SUPPLY OF 1*630 KVA DG SET FOR KOSTI TPS SUDAN

BHEL-ISG ENQUIRY NO: 77/15/6105/ANA DATED 19.08.2015

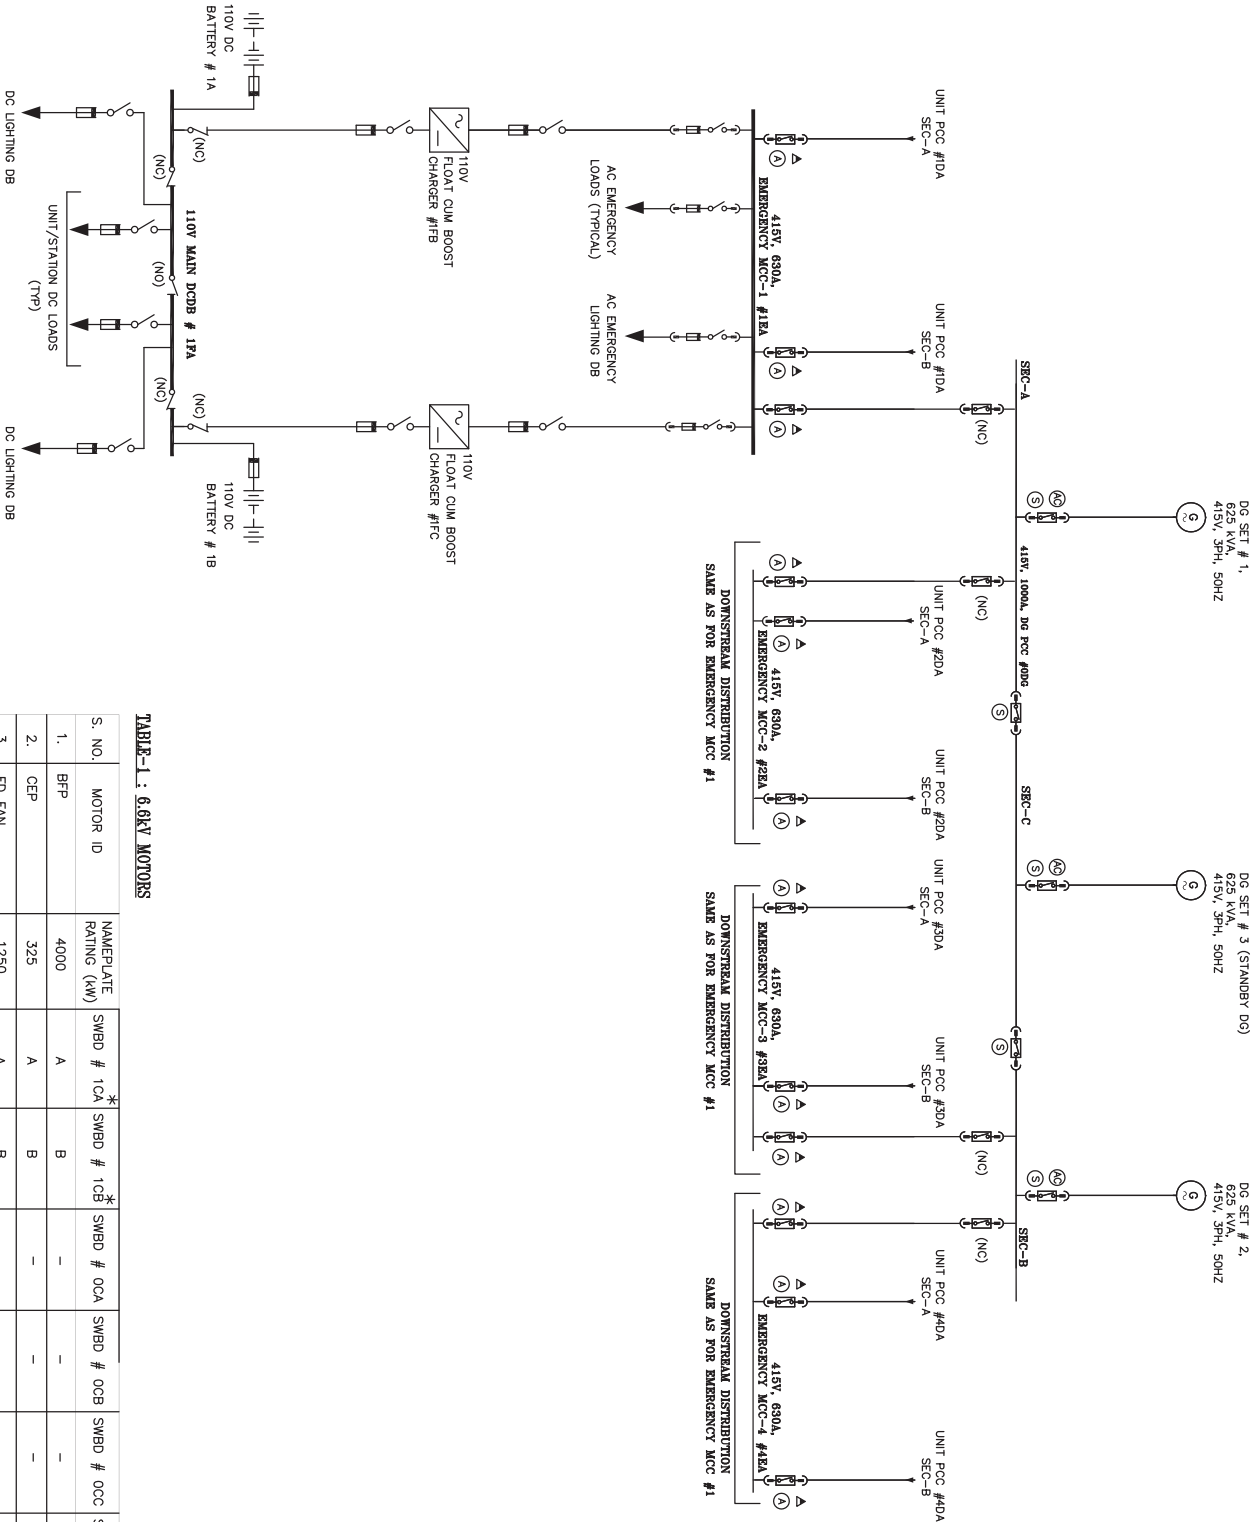
3	Kindly advise if we need to supply oil filter . Fuel filter , Air filter for the 1*630 KVA MTU gensets or for the existing gensets also.	As mentioned in the enquiry the new DG Set shall be of same rating(630 KVA) and make(MTU 12V2000G23+Stamford HCI544F-S/LVI634E1 Alternator) of the existing 2 DG Sets. So 3 Set of filters needs to be supplied specific to MTU 12V2000G23 engine , so that when required the filters may be replaced in any of the 3 DG Sets.
4	COMAP AMF 25 relay is provided for existing DG Sets . Woodward MFR- 13 relay is provided for electrical protection. Please note that COMAP AMF 25 cannot achieve synchronization operation with Mains , 2 Units of existing gensets and new 1*630 KVA MTU genset. If synchronization operation is mandatory . Then all three gensets shall be equipped with COMAP- IG - NT controller. This will involve the replacement of the controllers of existing gensets and associated wirings. Kindly send us the SLD to clarify the point.	Please note that synchronization of the DG Set with the Mains Incomer shall be manually done by the operator from electrical control panel(ECP) located in Plant control room through Voltage raise/ lower and frequency raise /lower pushbuttons and Synchronizer available on ECP. There will not be any involvement of DG set controller in synchronization process. Moreover synchronization between the existing DG Sets and the new DG set is not envisaged at all. The SLD is attached for your reference.
